Soils and Geology Report

Southern Rail Park Spur

V1_Soils and Geo comments.pdf Markup Summary

SOILS MAP
SOUTHERN RAIL SPUR
EL PASO COUNTY, COLORADO
FIGURE 2

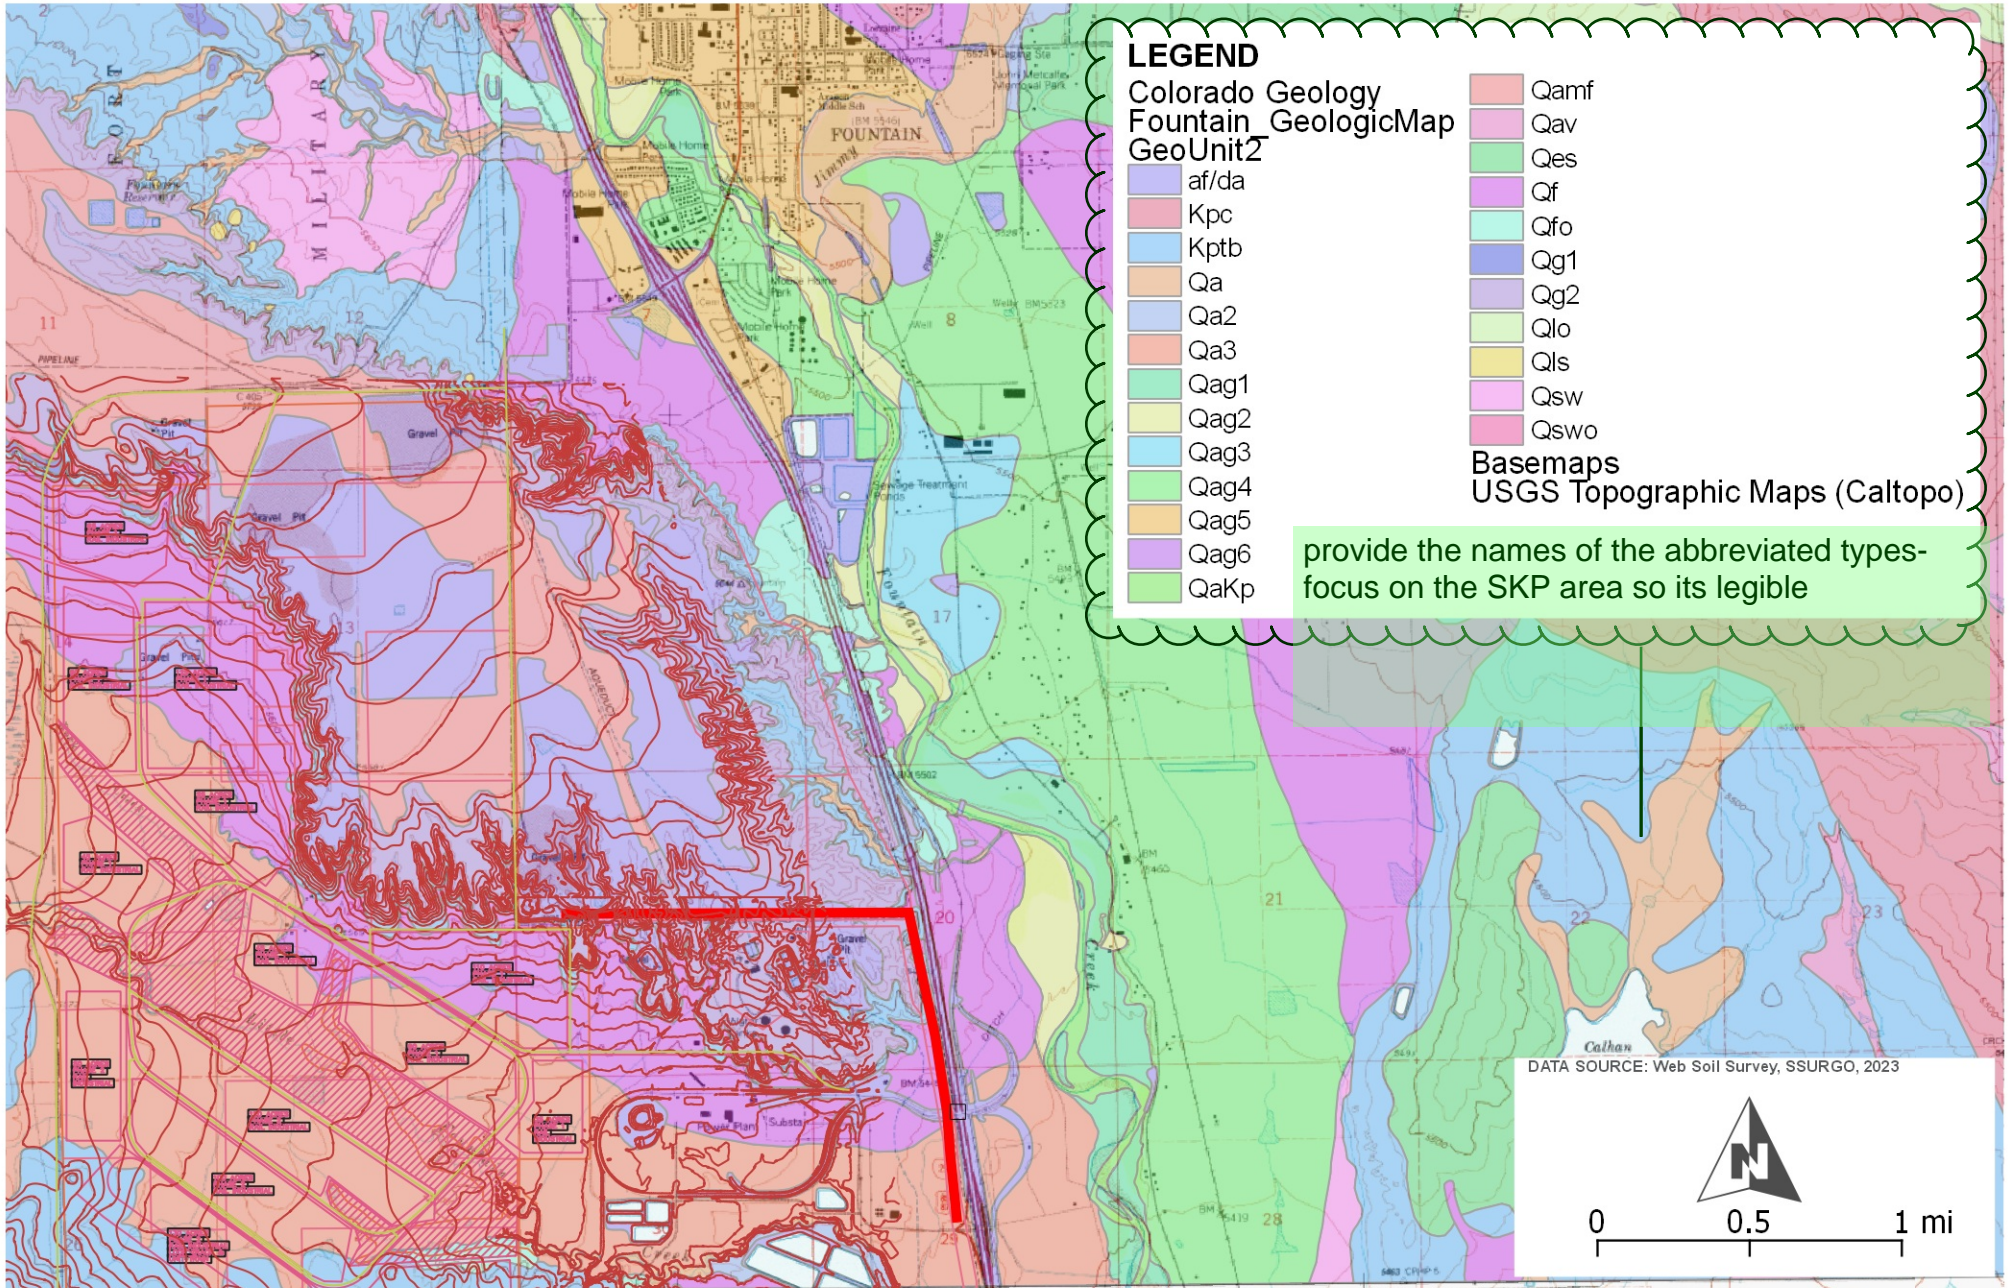
provide the names of the abbreviated types-
focus on the SKP area so its legible

provide the names of the abbreviated types- focus on the SKP area so its legible

GEOLOGIC MAP
SOUTHERN RAIL SPUR
EL PASO COUNTY, COLORADO
FIGURE 3

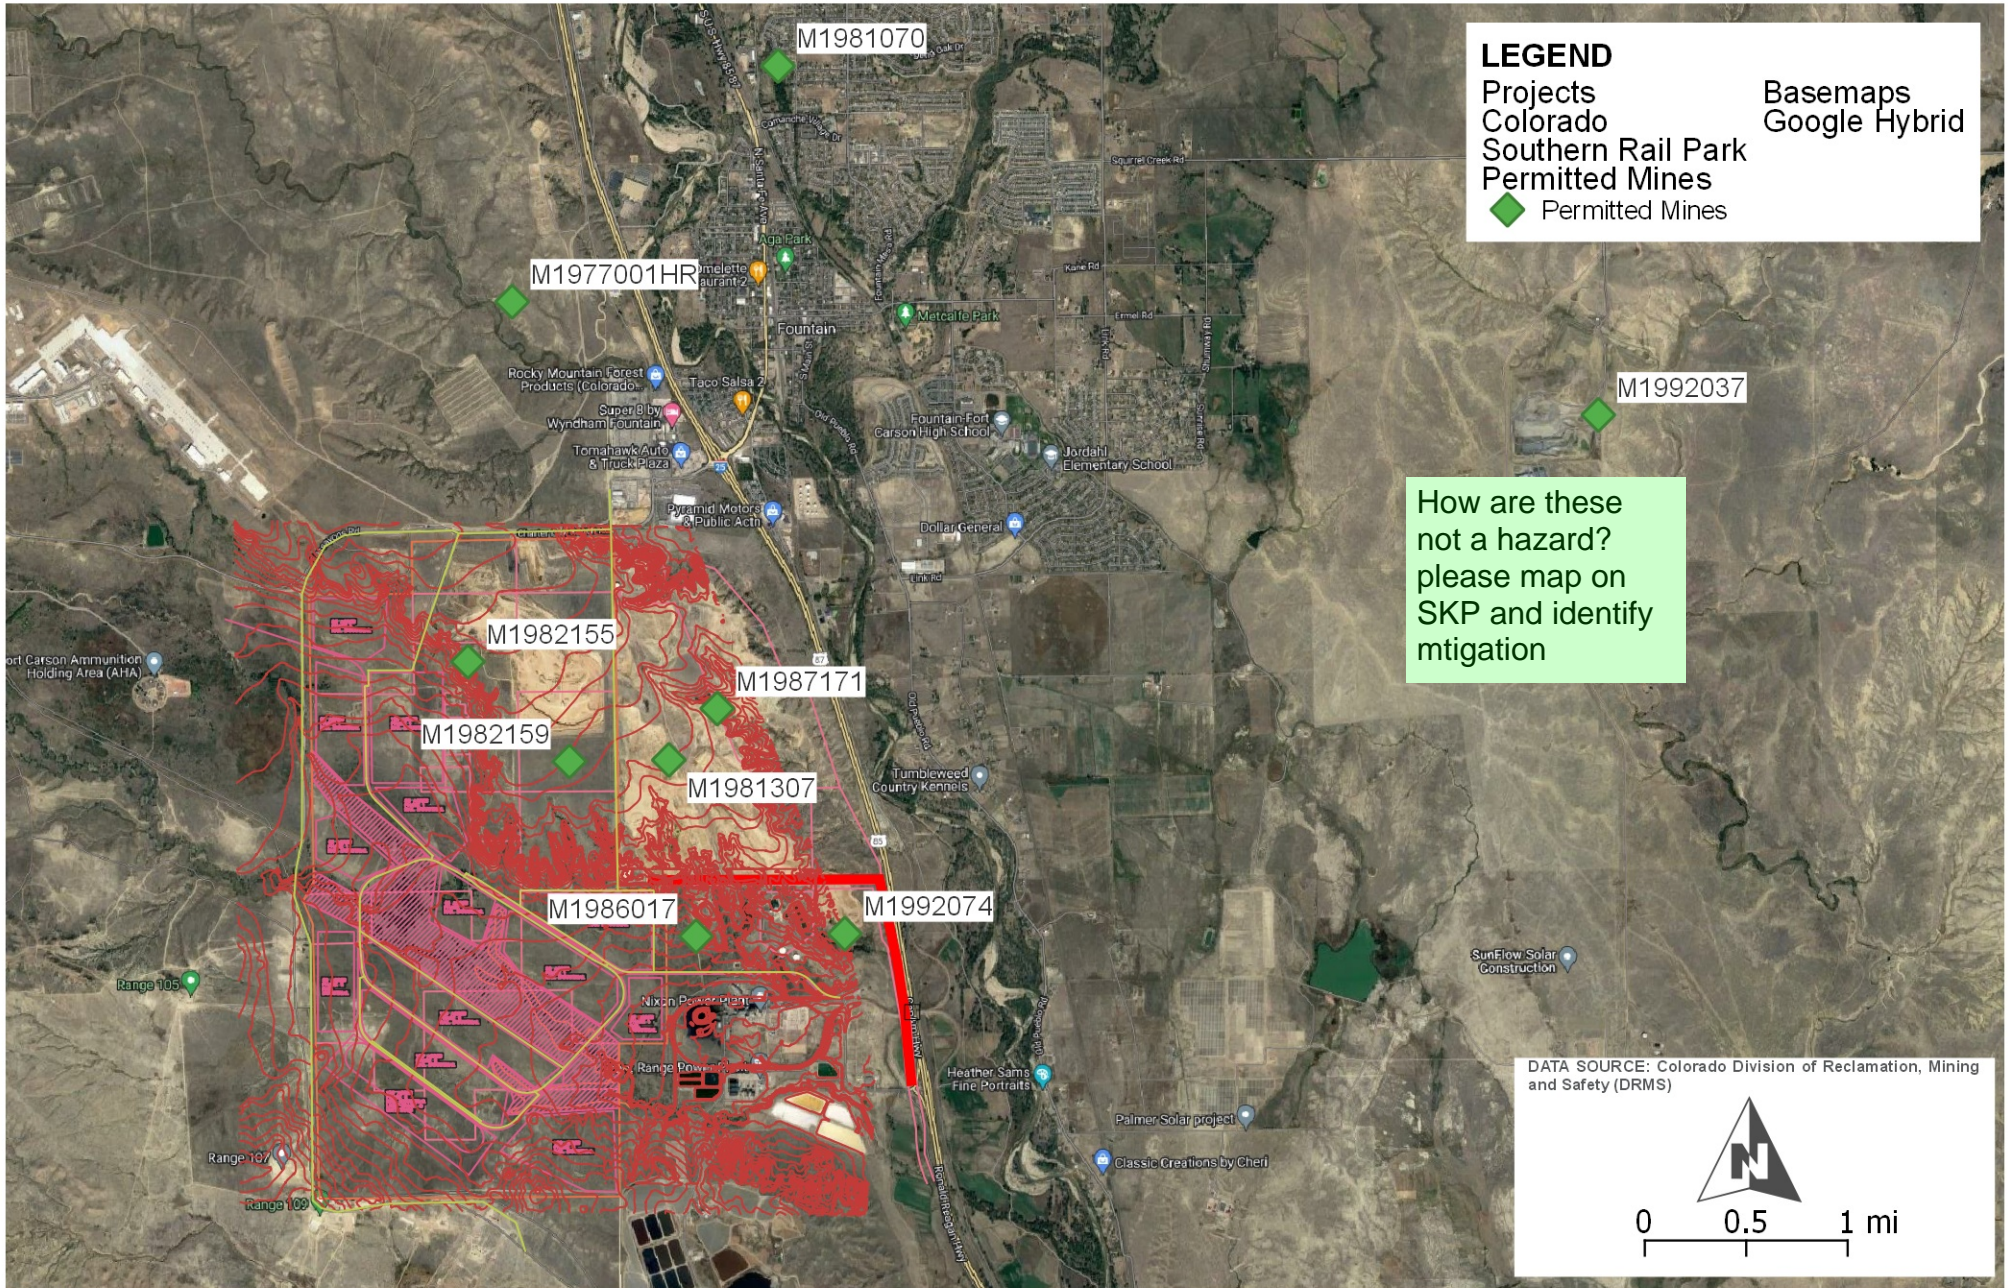
provide the names of the abbreviated types- focus on the SKP area so its legible
